Project Name: ANCHORAGE INN - ADDITION Map: 137 Lot: 35 Date: 1/9/2021

Ref: Anchorage Inn – 14 Wadleigh Road

The following updates are made to this revised set:

ANCHORAGE INN
14 WADLEIGH
ROCHESTER NH

EXISTING CONDITIONS &
DEMOLITION

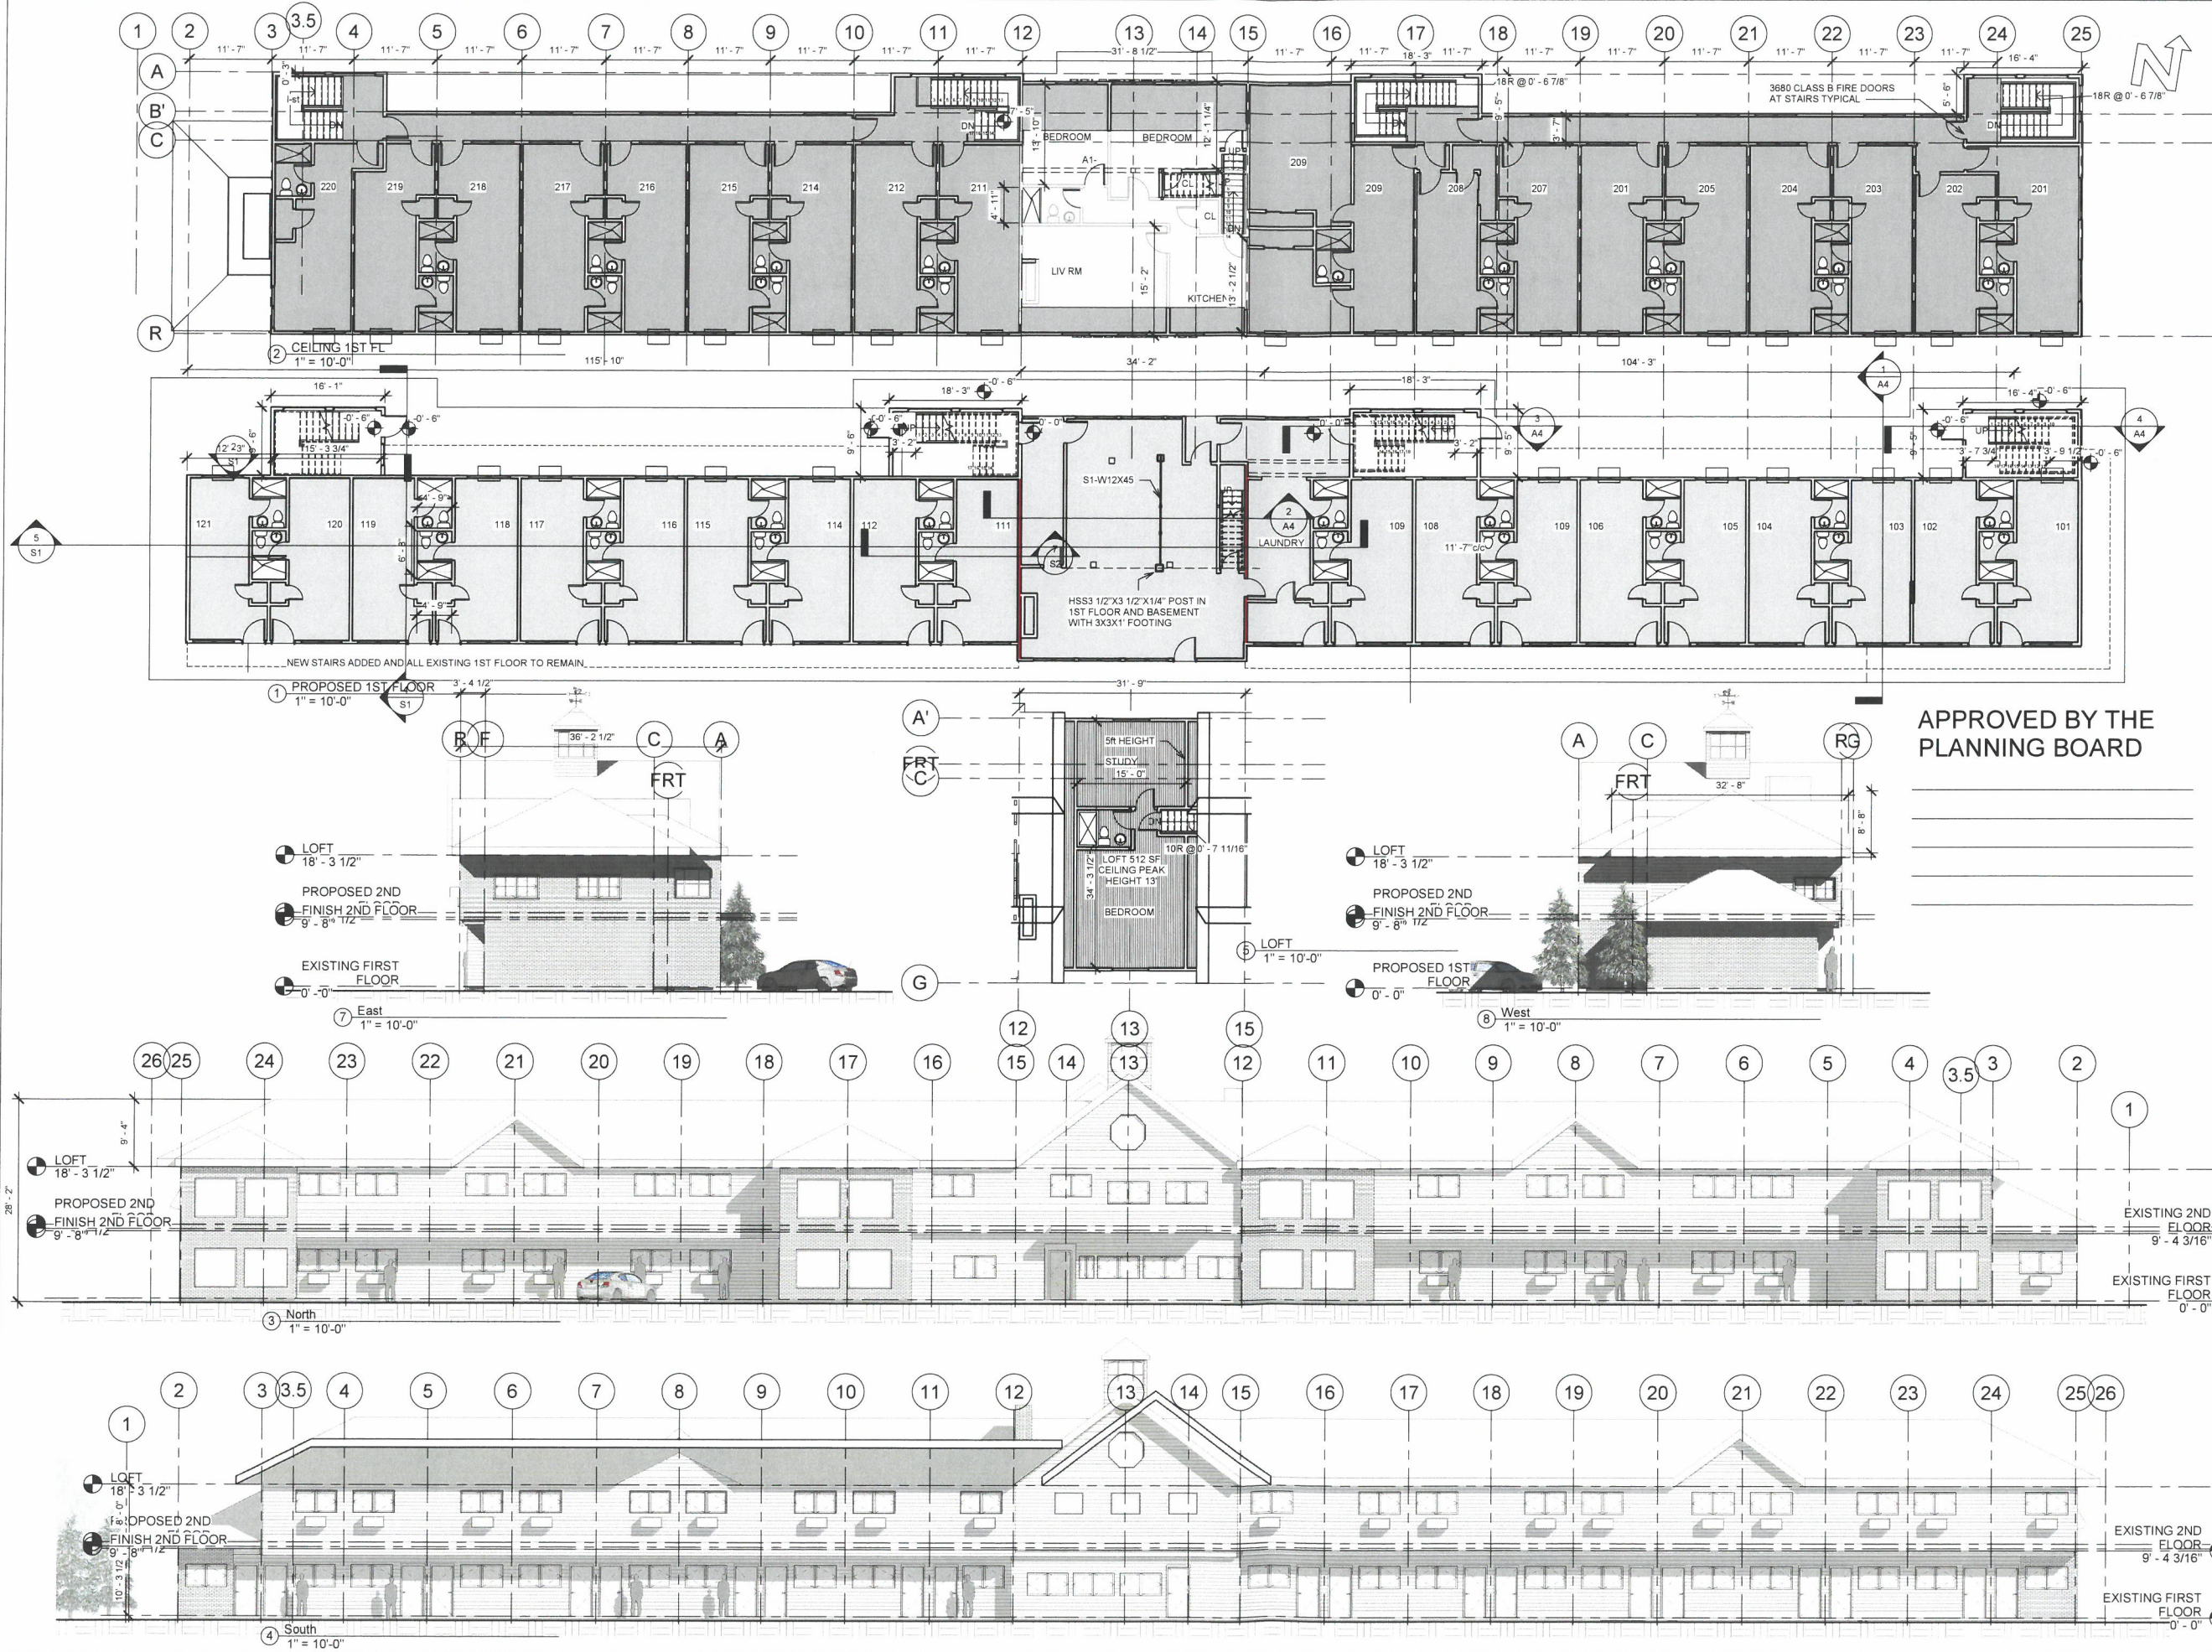
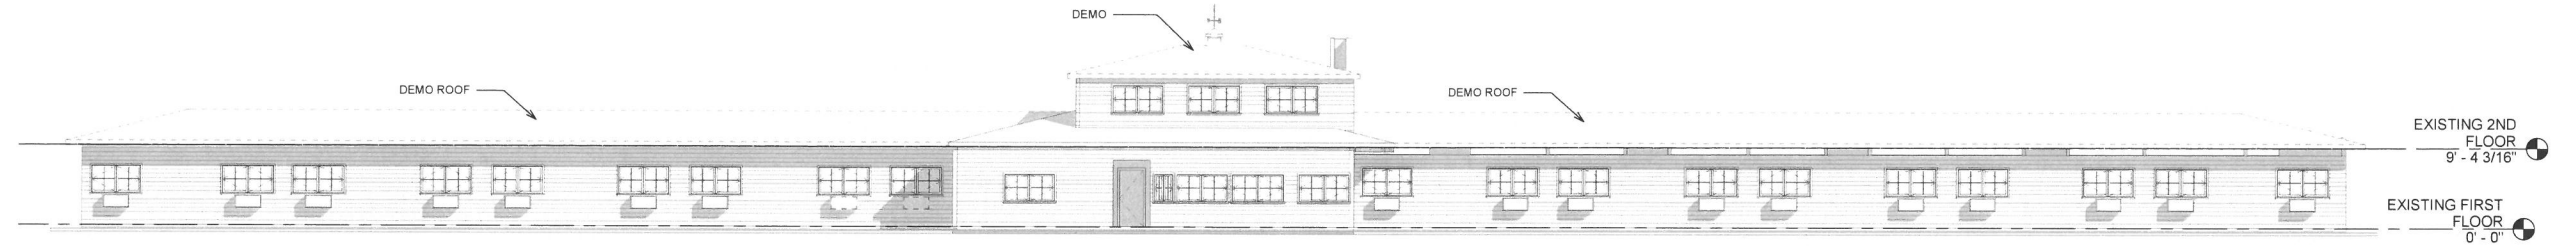
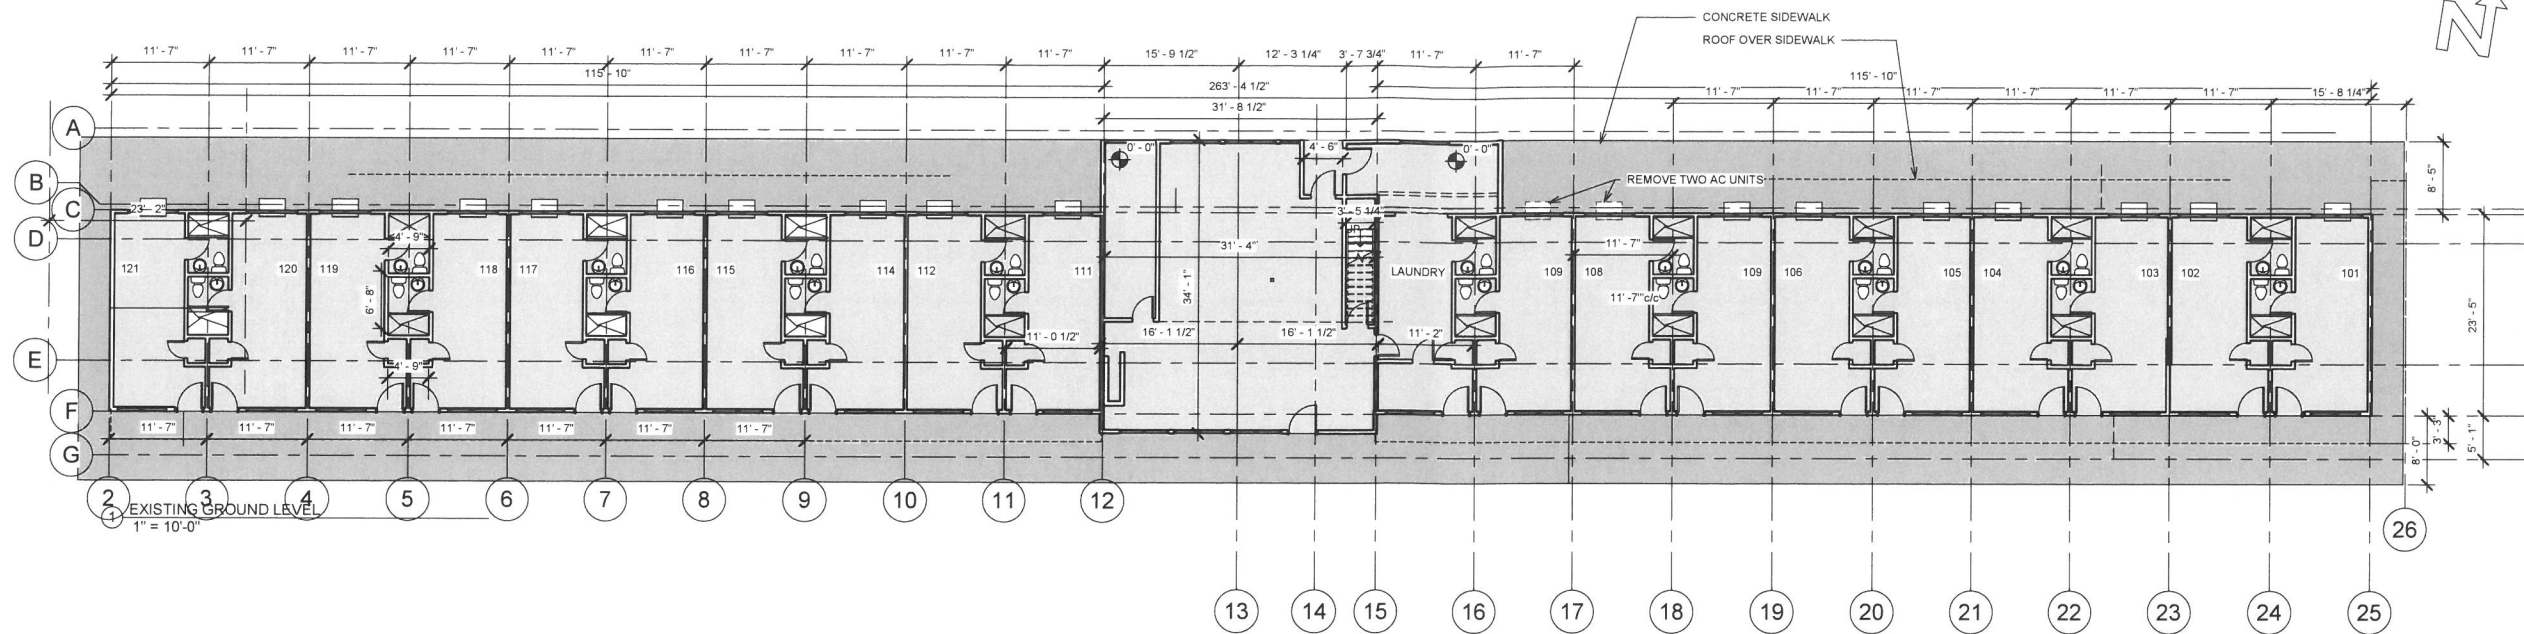
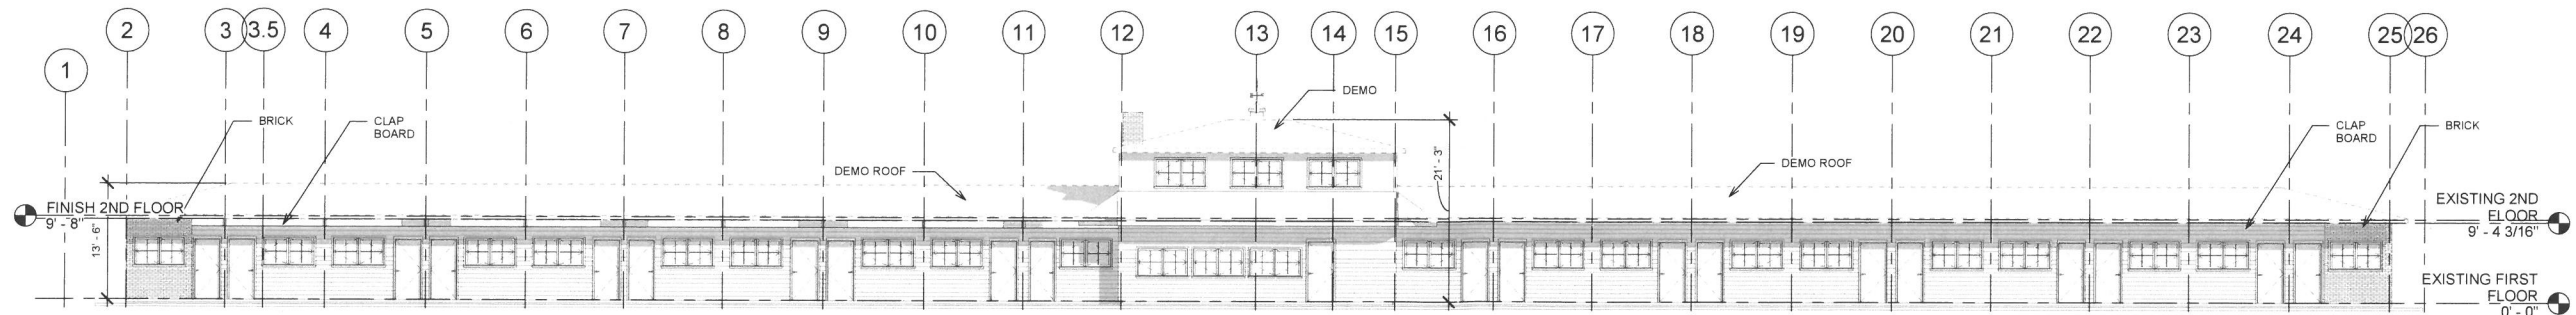
- e) Demo plan (as cited in the application) – The Existing building plan A2 is now clearly identified for the demolition of the roof.
- f) In addition, the existing Proposed – Phase I plan shows incorrect 100 feet wetland buffer. Please add to this plan width of paved areas walkways patio's etc.. – There was a discrepancy in the 100ft buffer zone line and has been corrected showing the 100ft dimension from the wetland flags.

PROPOSED LANDSCAPE
AND LIGHTING

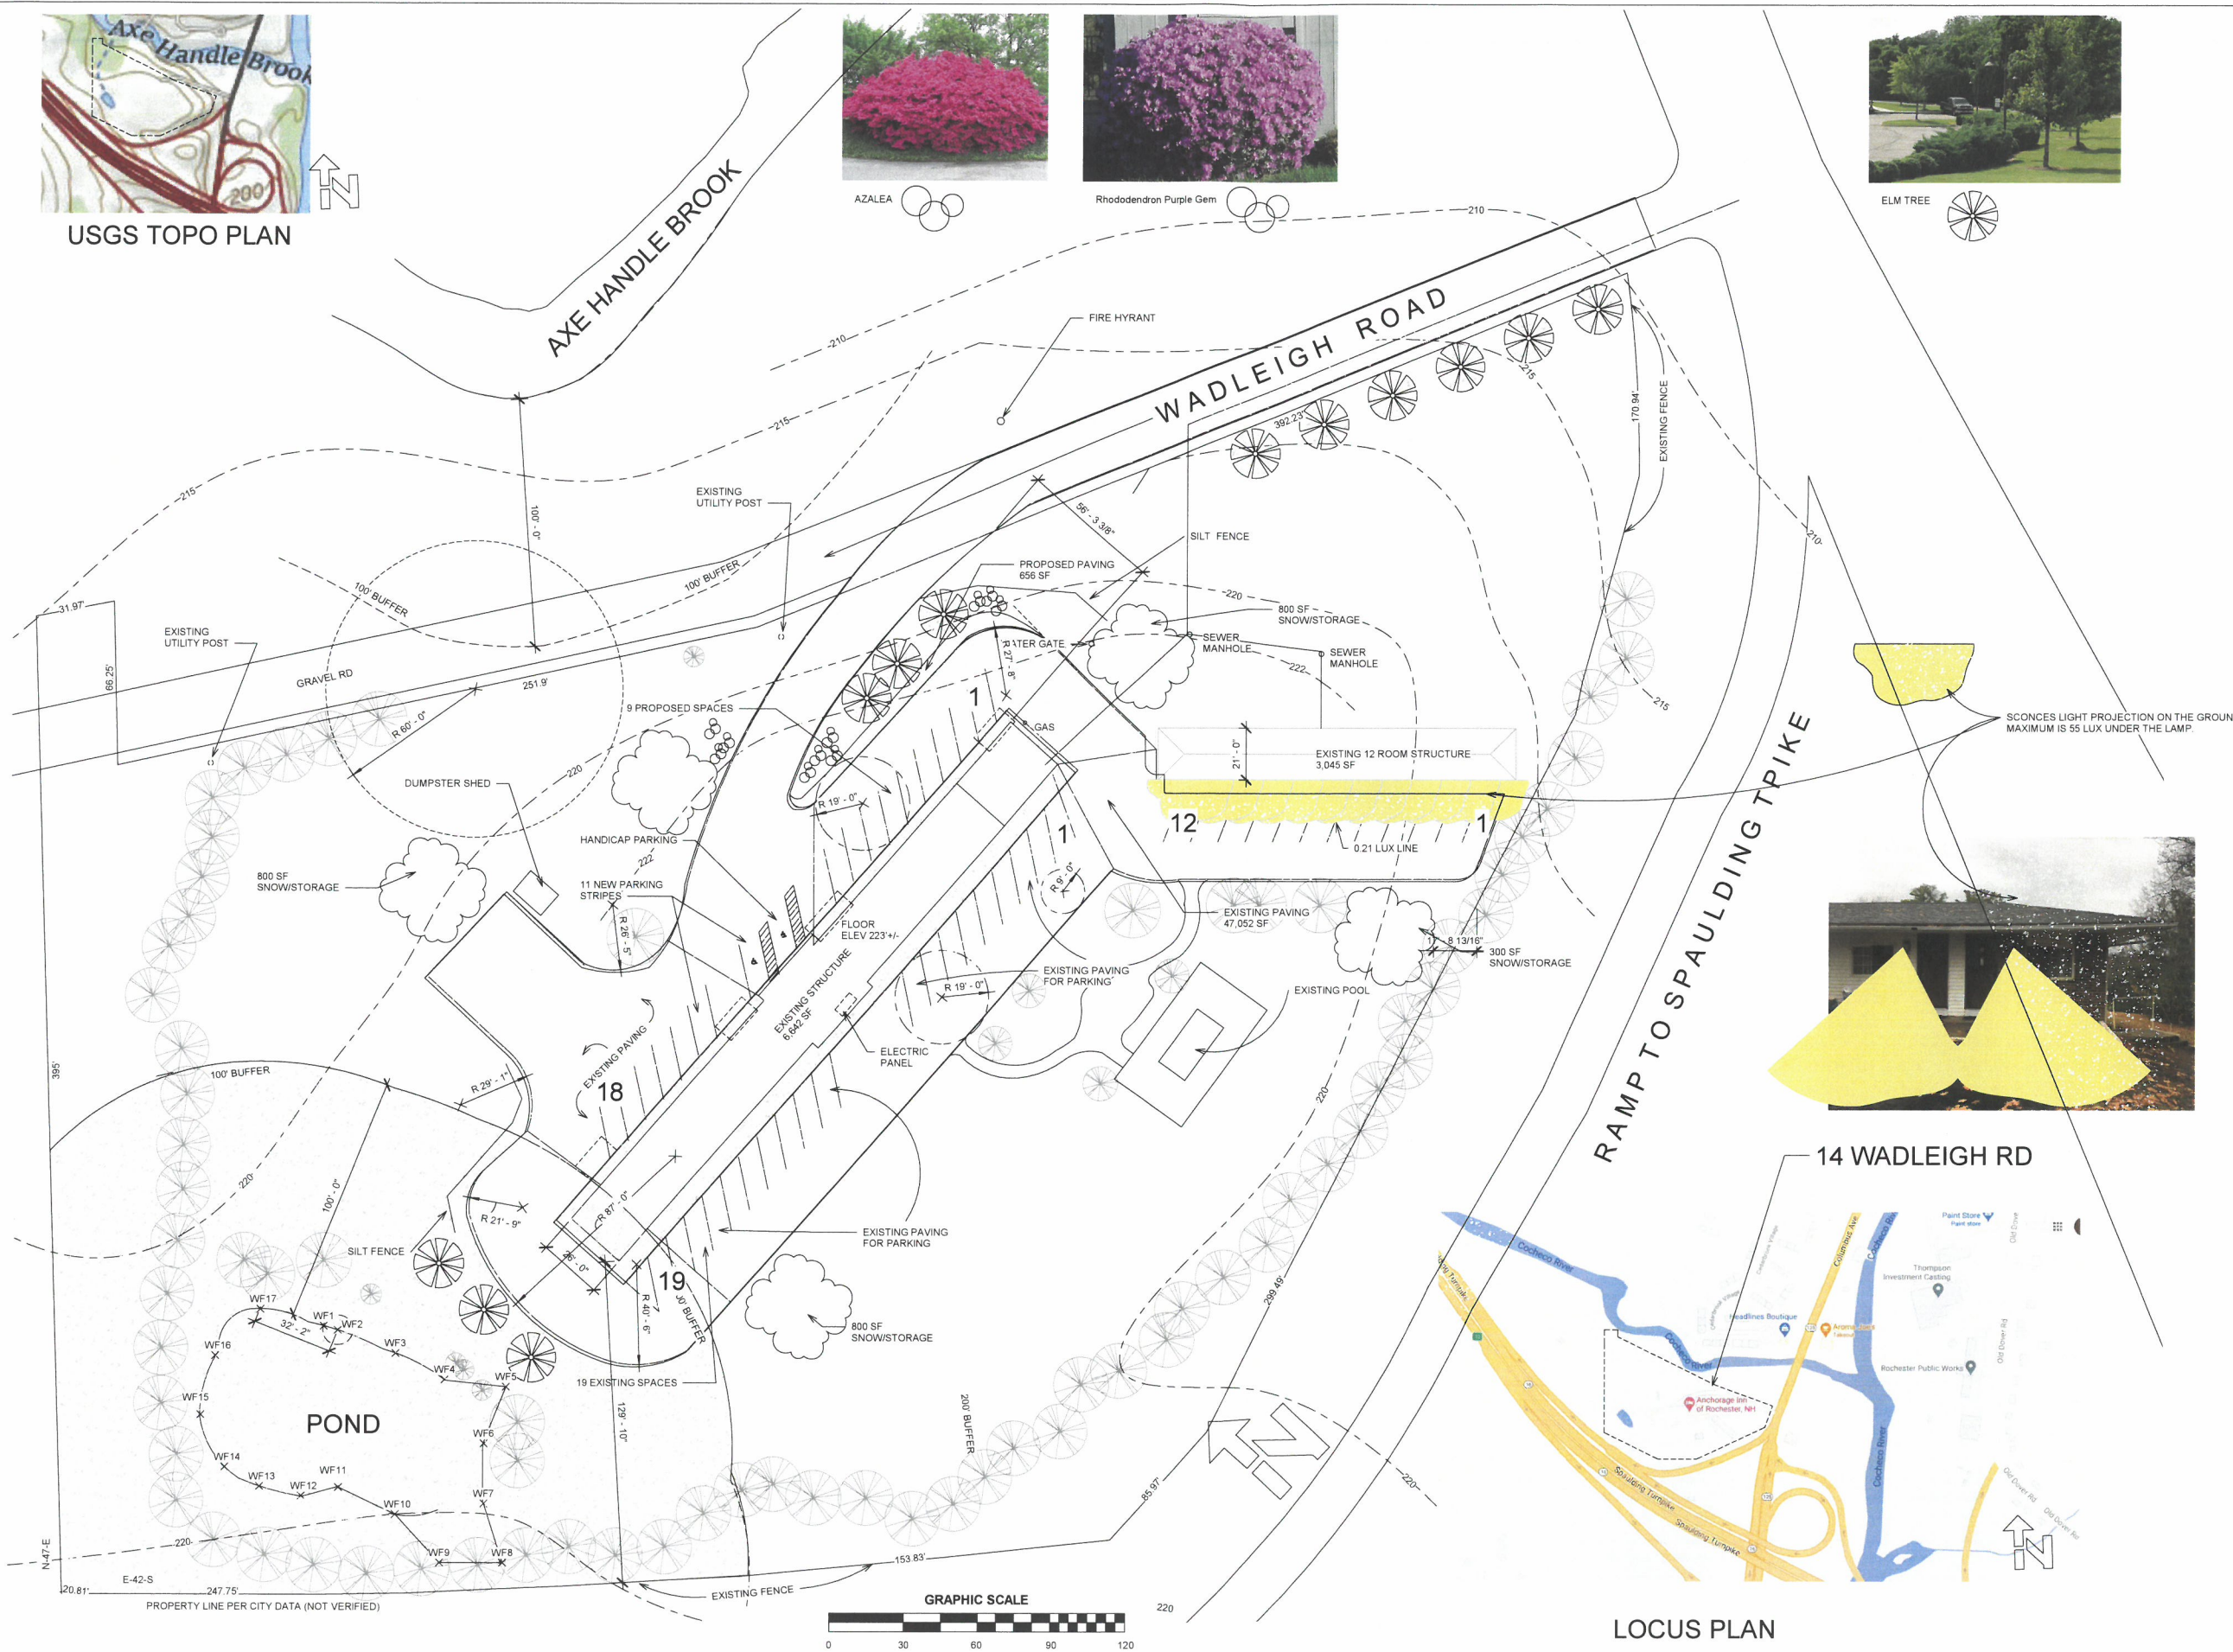
- b) Landscaping plan – C2 sheet is added to show proposed trees and bushes. As you will read the narrative of this project, an insignificant paving is proposed. No trees or bushes have to be cut or removed for the proposed 2nd storey addition. Existing paving has adequate width for the parking required.

- b) Lighting plan – C2 sheet also shows the additional lighting installed on the building façade to illuminate the parking area.
- c) Stormwater plan which shows drainage, grading and erosion control for construction of the additional parking area. - As described above there is no new paving being proposed for the additional parking. Existing paving will be painted with parking lines to demark the required spaces. At present this paving is not being used for parking as there is no demand from the existing 19 rooms. Therefore, there is no requirement of drainage system as no new runoff is being created.
